**Record of Decision**  
**Vanadium Corporation of America Site**  
**Operable Units No. 1, 2 and 3**  
**Town of Niagara, Niagara County New York**  
**Site Number 9-32-001**

**March 2006**

## **DECLARATION STATEMENT - RECORD OF DECISION**

# **APPENDIX A**

**Figure 2**  
 SITE PLAN  
 PHASE III AND IV - RI/FS  
 VANADIUM CORPORATION OF AMERICA SITE  
 Niagara Falls, NY

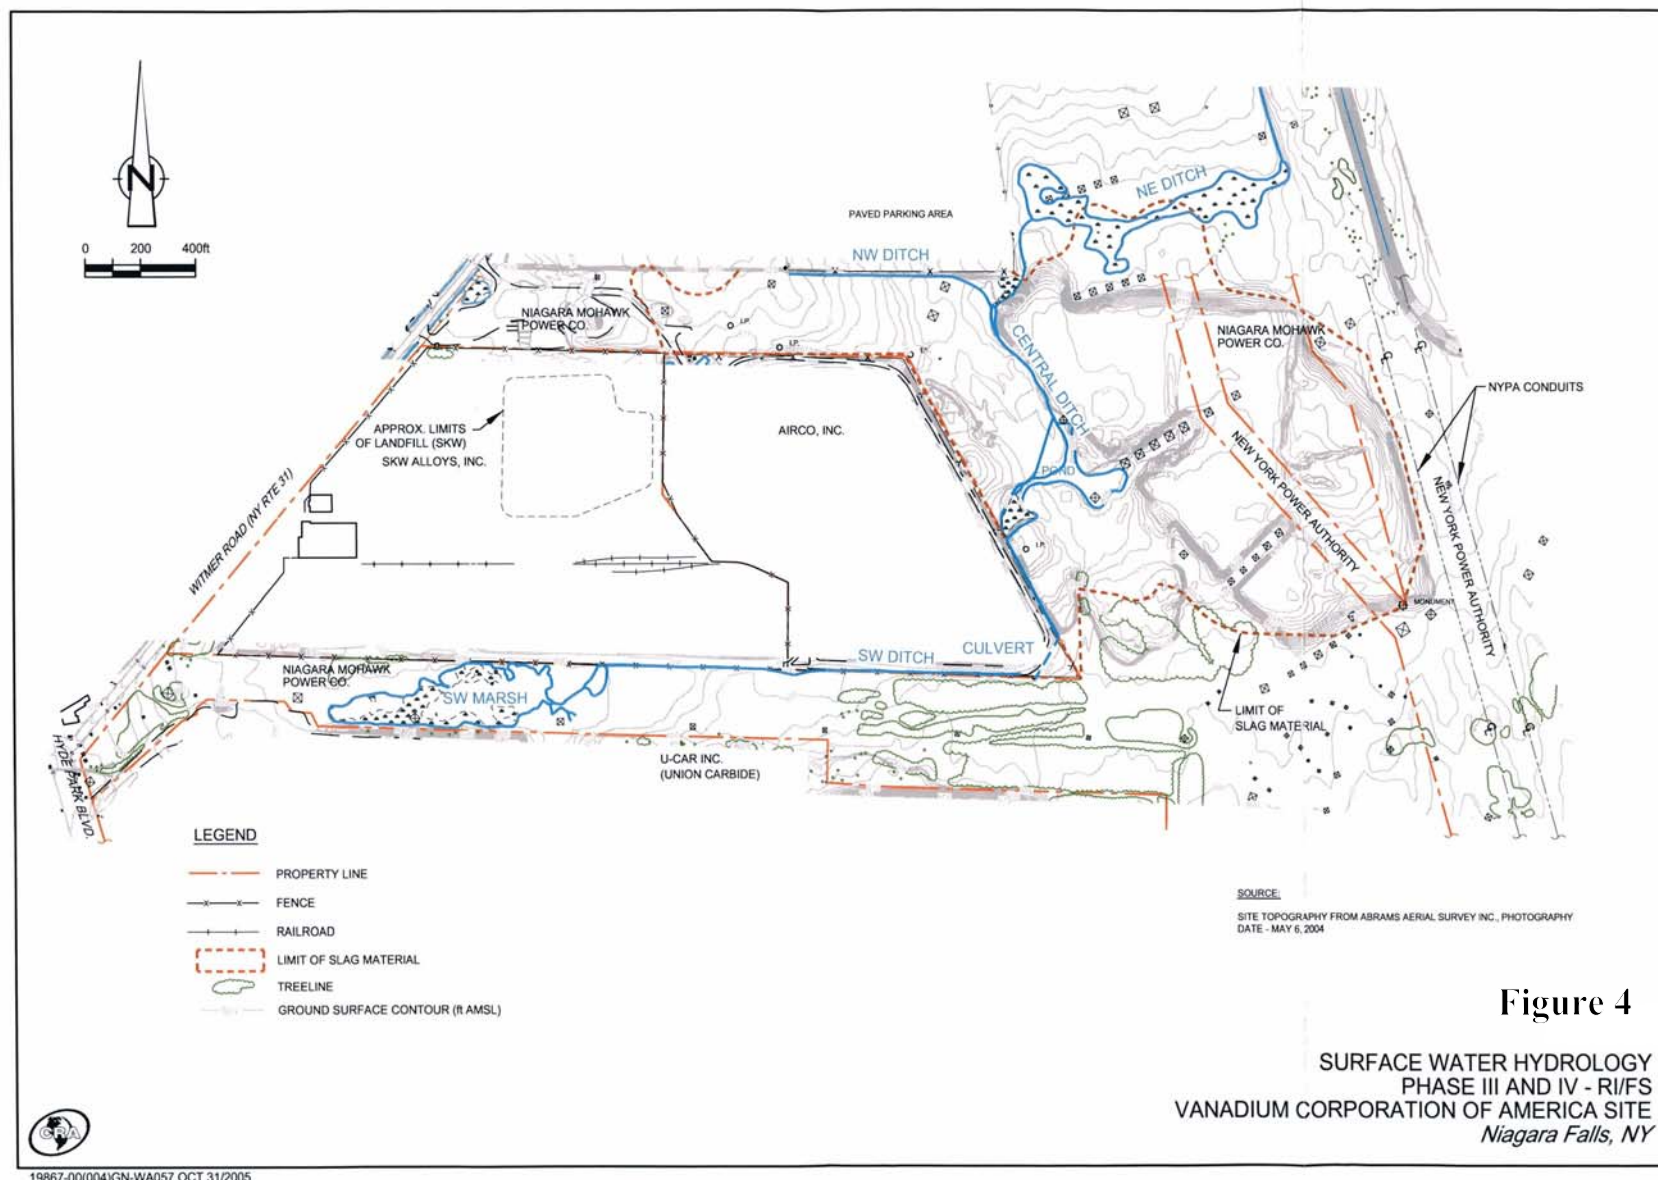
Over the majority of the area of OU-3, the slag material has a soil cover. However, there are areas where the slag is exposed at the surface (see Figure 2). A total of 18 surface slag samples were collected from the areas where the slag is not covered with soil.

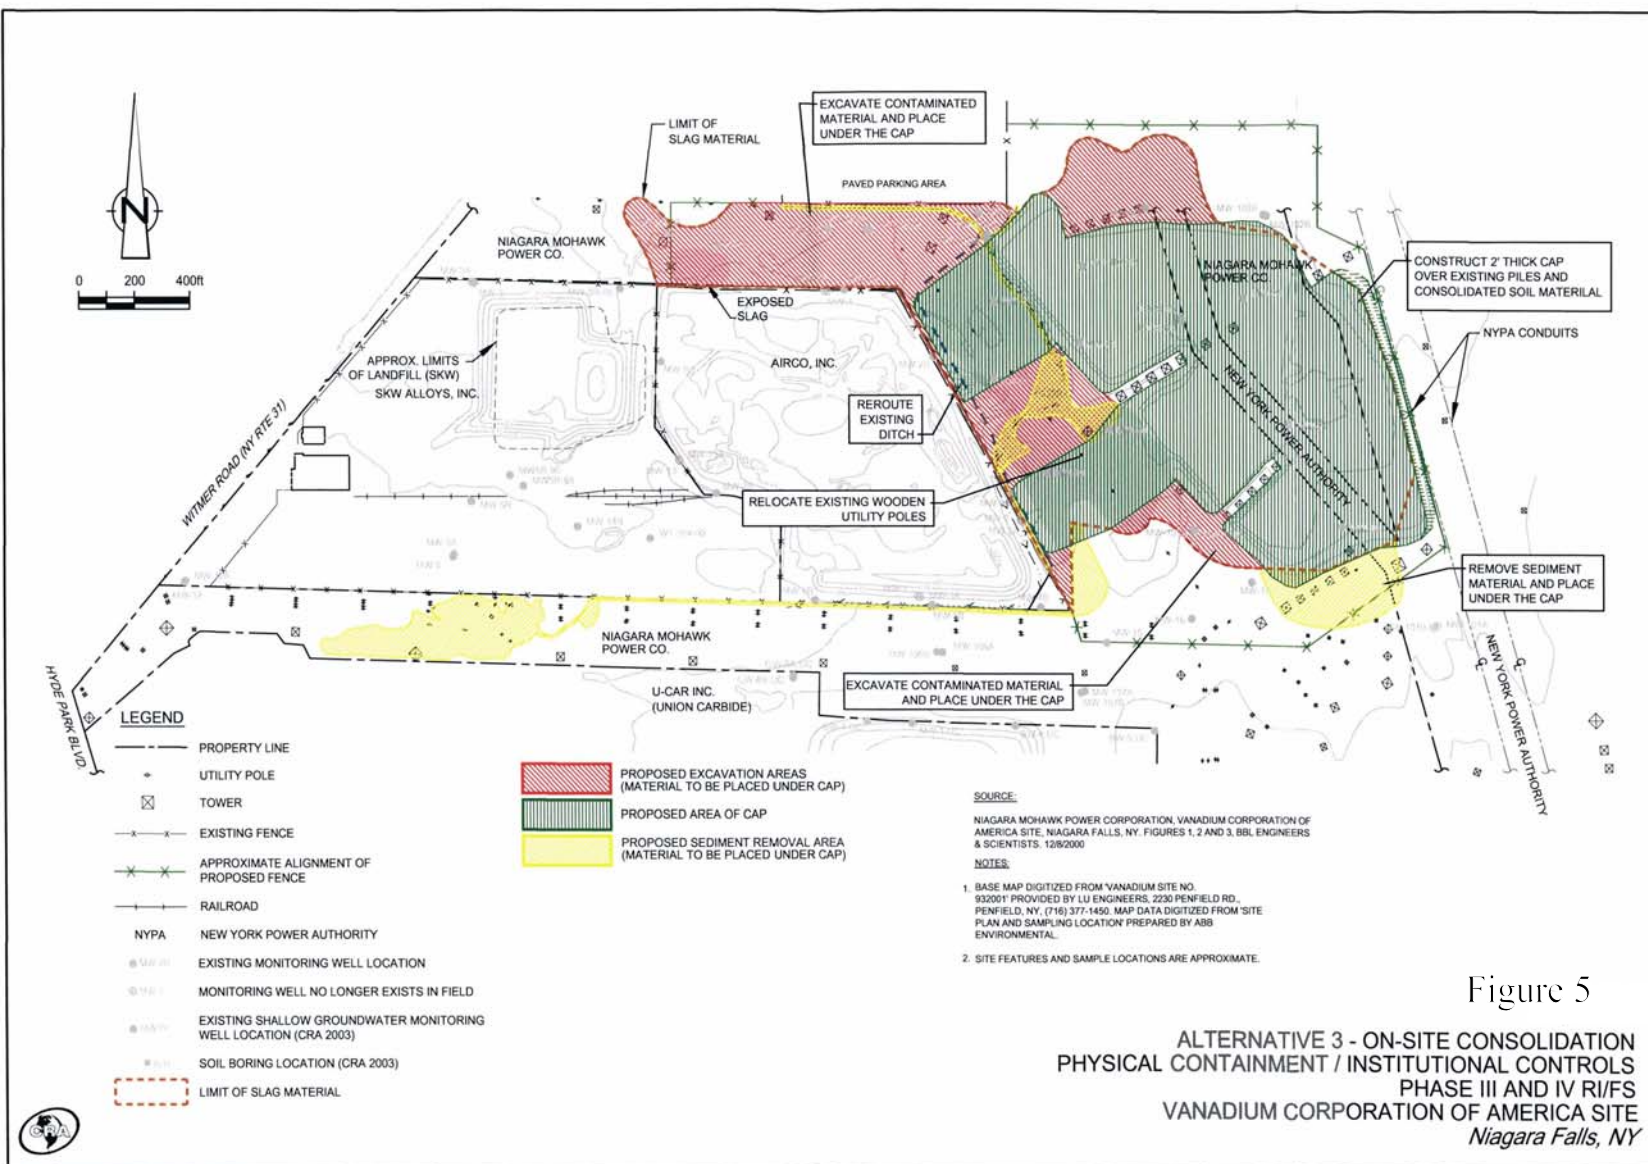
- COMMENT 12:** So what this cleanup is proposing is to contain the contamination, not remove it?
- RESPONSE 12:** That is correct.
- COMMENT 13:** In the figure that shows the proposed area of the cap, what does the square in the middle represent?

- RESPONSE 13:** Drainage from the power transmission tower bases must be provided. The square is the area that will not be filled with excavated material to facilitate the drainage requirements.
